Divine Design Ltd. Alamode Apparels

Chittagong, Bangladesh
(22°22'55.5"N 91°51'53.5"E)

20 APRIL 2014

Observations

Highly Stressed Columns at Ground Floor

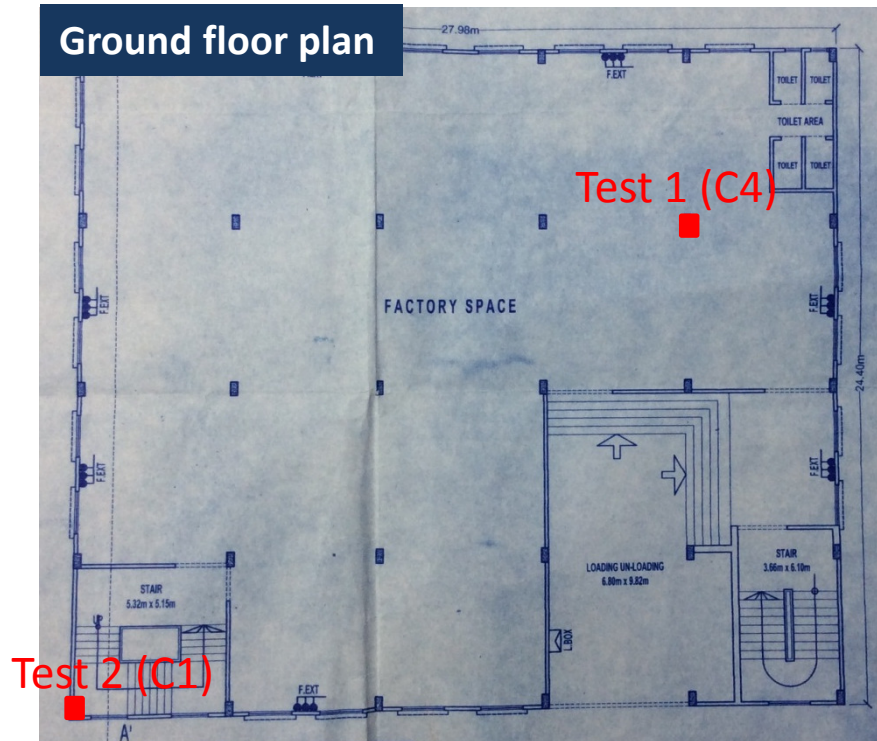
Highly-stressed columns at Ground Floor

Specific design check to be carried out on all columns

Cursory calculations indicate that columns are stressed in excess of normal design limits. Reasons for this may stem from the following:

- Cantilever increases load on the first column particularly when loaded with storage.
- Internal partition walls in brickwork adding to the general live load.
- 8 floors in parts of the building. Whilst the building appears to have a permission for 8 floors this may not have been taken account of in the original design.
- Storage load in excess of usual 3kPa, the design load for slabs according to code.
- Brick aggregate found in the columns instead of stone aggregate as suggested on structural drawings.

Tested Ground Floor Column – Brick Chips

Check column stresses and verify concrete strengths in columns surrounding stair core

- Only lightweight operations (max. 100kg/m² - 1kPa) or access ways / escape routes are permitted in shaded zones at all levels. No storage allowed.
- Verify insitu concrete stresses by cores (100mm diameter) at min. 4 no. non-critical columns on ground floor.
- **Detail Engineering Assessment to be commenced immediately, see attached scope.**

- Produce and actively manage a loading plan for all floor plates within the factory giving consideration to floor capacity and column capacity.
- Detail Engineering Assessment to be completed

- Reduce dead load / live load or carry out strengthening as required.

High loadings on slab

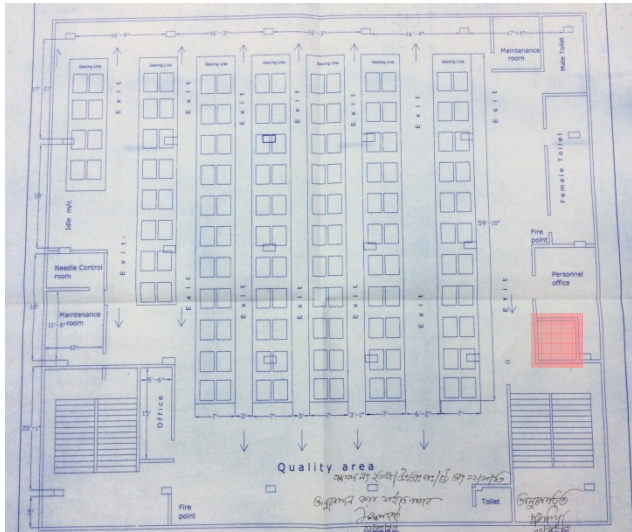
**High loadings on slab
(storage, toilet areas with brick partitions)**

Toilet Build-up + partition walls

Storage 6th floor

Storage 2nd floor

Building Engineer to prepare controlled loading plans, based on floor slab and column capacity, for all floors which will designate maximum permitted storage density and where storage may be placed.

- Extent of floor build-up and partition walls and their respective loads onto the slab to be surveyed / identified and compared against the capacity of floor slab which will be assessed as part of Detail Engineering Assessment (Refer to Item 1)

- Reduce dead load / live load or carry out strengthening of floor slab as required.

Lift shaft on architectural drawing

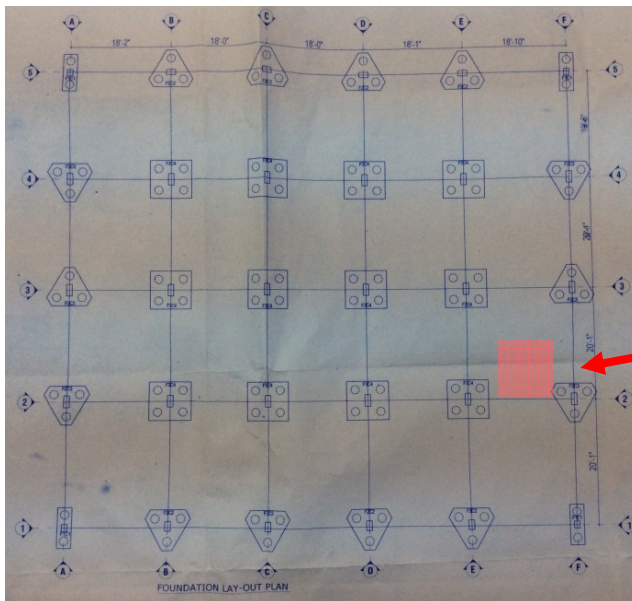
Structure of unused lift shaft not clear

Water tank on top of lift shaft

Unused lift shaft

No information about lift shaft on structural drawings:

- No foundation shown,
- Not clear if brick or concrete,
- Not clear if borne by each slab on each level or actually load-bearing

- Should be kept unused.

- As part of Detail Engineering Assessment (refer to Item 1), Building Engineer to commence re-survey of as-built structure and check foundation for the unused lift shaft.

- Take actions as required by the results of the Detail Engineering Assessment.

Cantilever slabs on all sides of the building

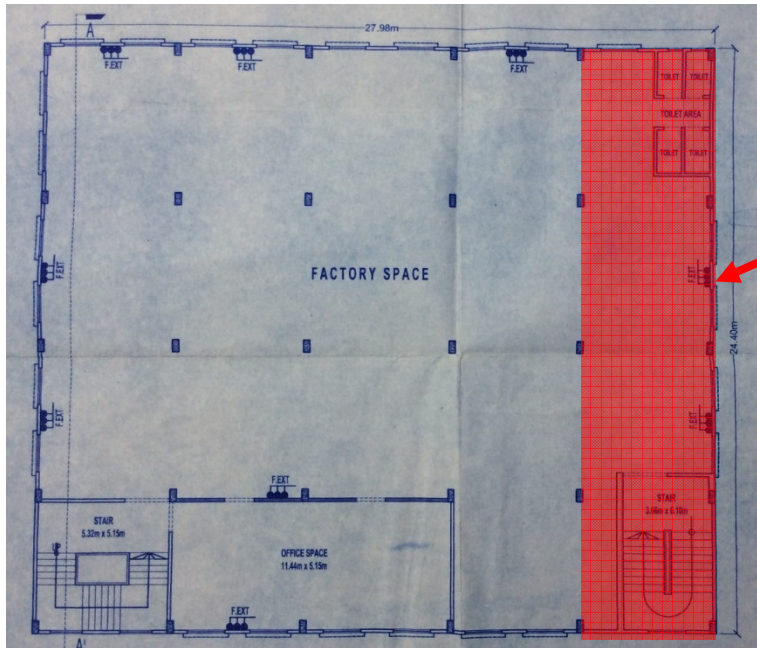
Cantilever slabs on all sides of the building

(Repaired) cracks: indication of high deflection of cantilever

Flat slab cantilever

High load on cantilever

- Remove storage from cantilever slabs.

- Create controlled loading plans for all floors designating where storage can / cannot be placed along cantilevering edges.
- Provide calculations showing the structural adequacy of the cantilever slab, taking into account the loading plans, facade and all built structure, including additions beyond the original design, as part of Detail Engineering Assessment (refer to Item 1).

- Reduce live load or carry out strengthening as required.

Lintel beam detail on level 1

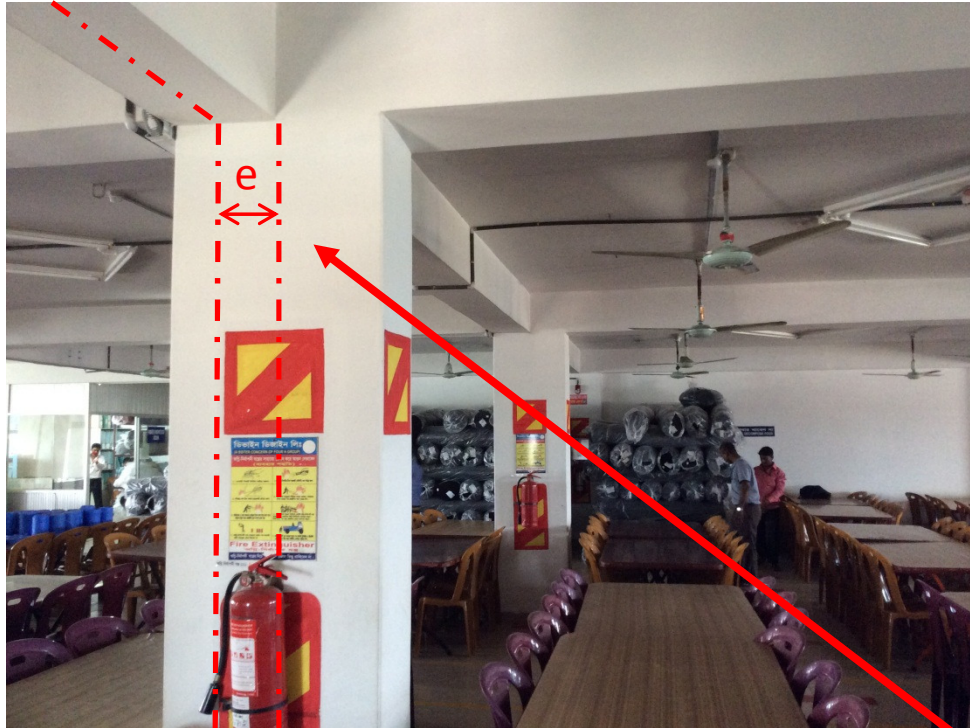
Lintel beam detail on level 1

Partly removed lintel beam
resulting in unsafe brickwork

- Provide temporary propping to lintel.

- Restore lintel beam.

Eccentric beam-column-connection

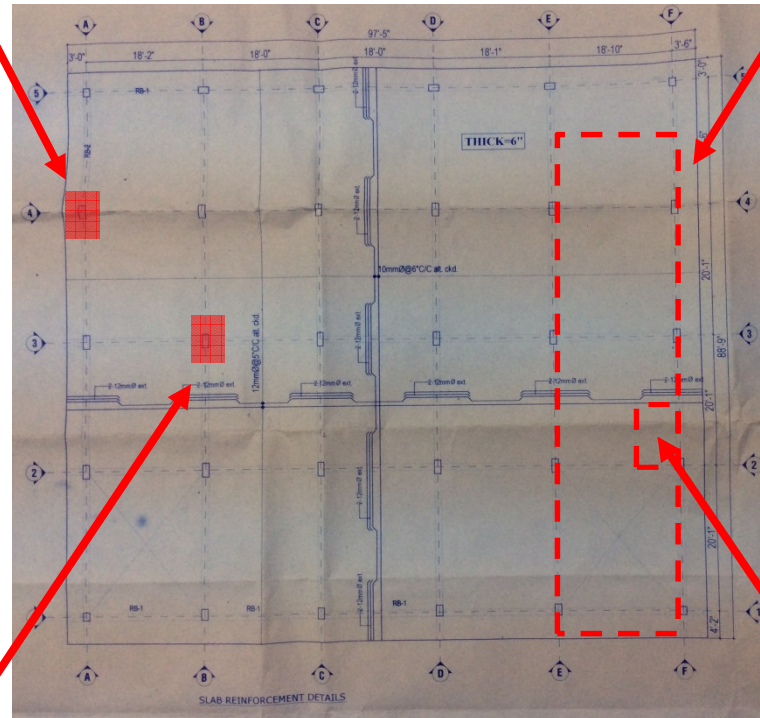
Eccentric beam-column connection

Eccentric beam-column connection
on every floor
(not shown on structural drawings)

- Provide calculations showing the structural adequacy of the building taking into account the eccentricity of the beam-column connection as part of the Detail Engineering Assessment (refer to Item 1).

Inaccurate drawing information provided

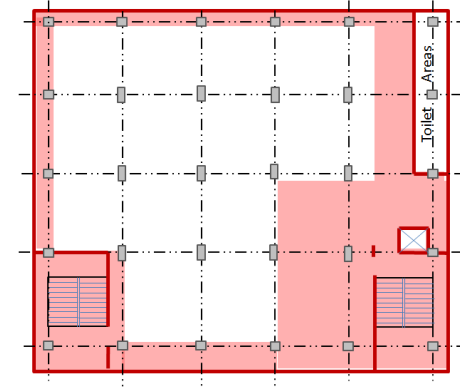
Inaccurate drawing information provided

Different column size for columns C3

Additional structure of one bay on roof not shown on drawings

Eccentric beam-column connection not shown on drawings

Lift shaft not shown on drawings

- As part of Detail Engineering Assessment (refer to Item 1), Building Engineer to commence re-survey of as-built structure and update drawings including a verification of the column sizes, lift shaft, beam-column connection etc.

- Complete as-built survey and Detail Engineering Assessment
- Produce and actively manage a loading plan for all floors within the Factory giving consideration to floor capacity and column capacity. (Refer to Item 1)
